BURNS AND ROE, INC.  
WPPSS  
NUCLEAR PROJECT  
NO. 2

PROJECT  
ENGINEERING  
DIRECTIVES

CODE	PROJECT ENGINEERING DIRECTIVE														
2 1	2	1	5	-	C	5	-	2	7	4	1				
1 2	3	4	5	6	7	8	9	10	11	12	13	14	15		
DATE	0	3	/	1	3	/	8	0	PRIORITY						
	16	17		18	19		20	21	II

REFERENCES	
SUBJECT	SAC. SHIELD WALL WELDS
LOCATION	EL. 541.5 ALL AROUND
ENG. SYSTEM	N/A
S/U SYSTEM	
QUALITY CLASS	I

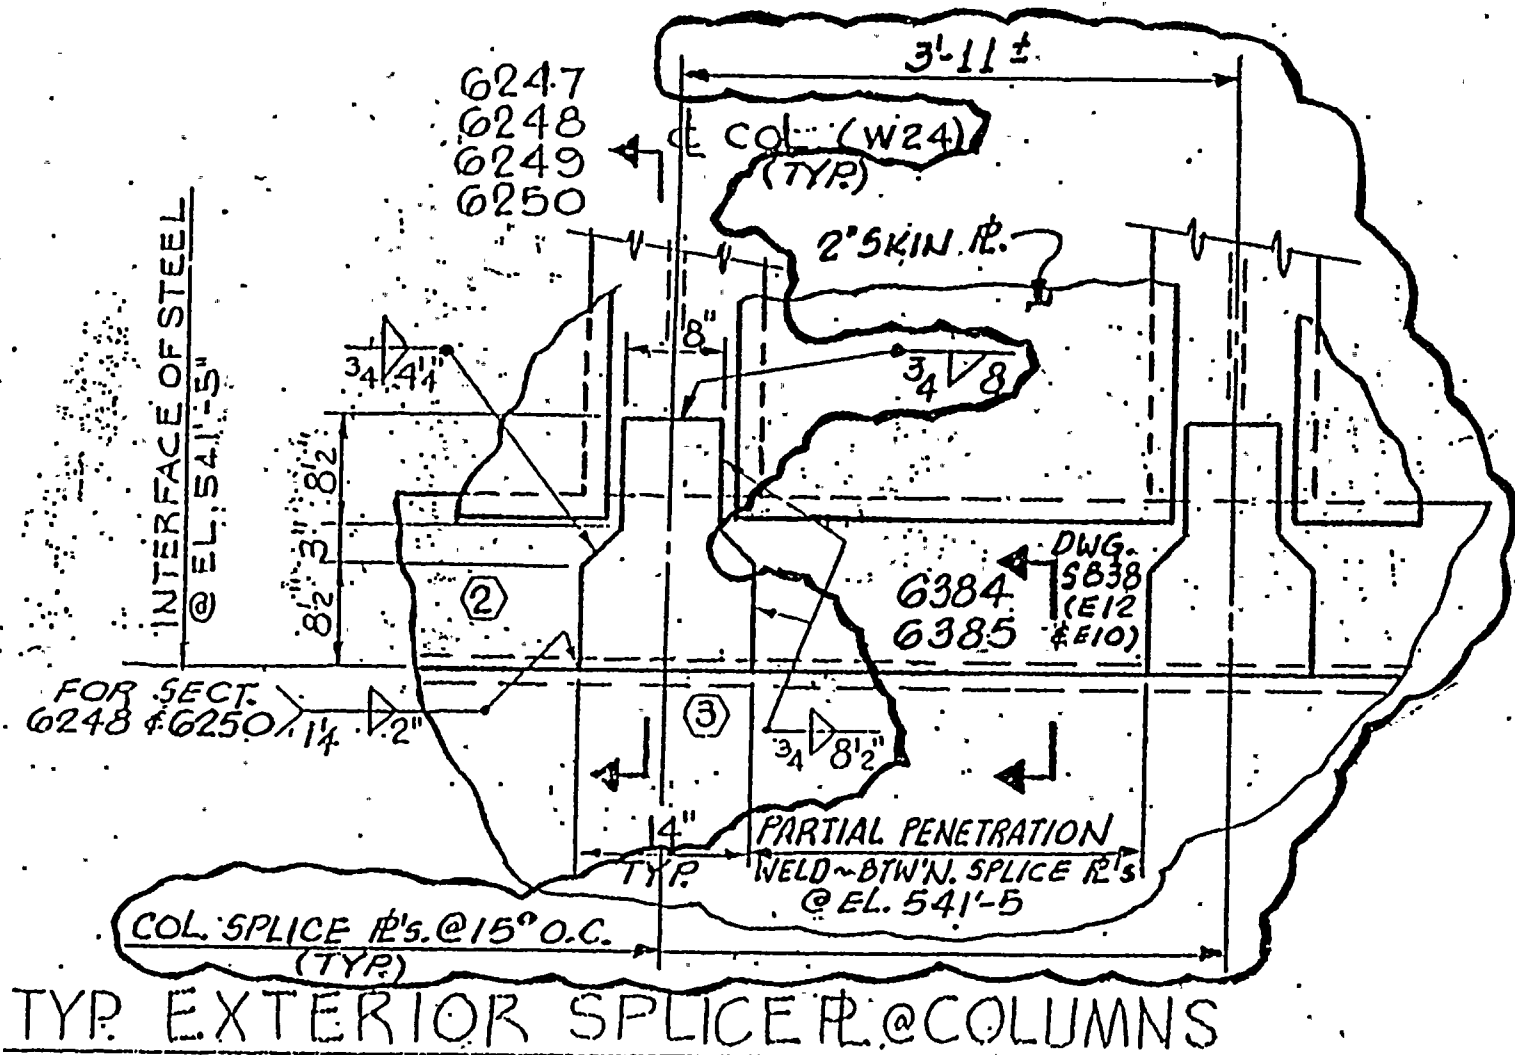
REPLACE SLOT WELDS WITH A PARTIAL  
PENETRATION WELD BETWEEN THE UPPER AND  
LOWER RINGS AS DETAILED ON SHEETS 3  
THRU 5 OF THIS P.E.D.
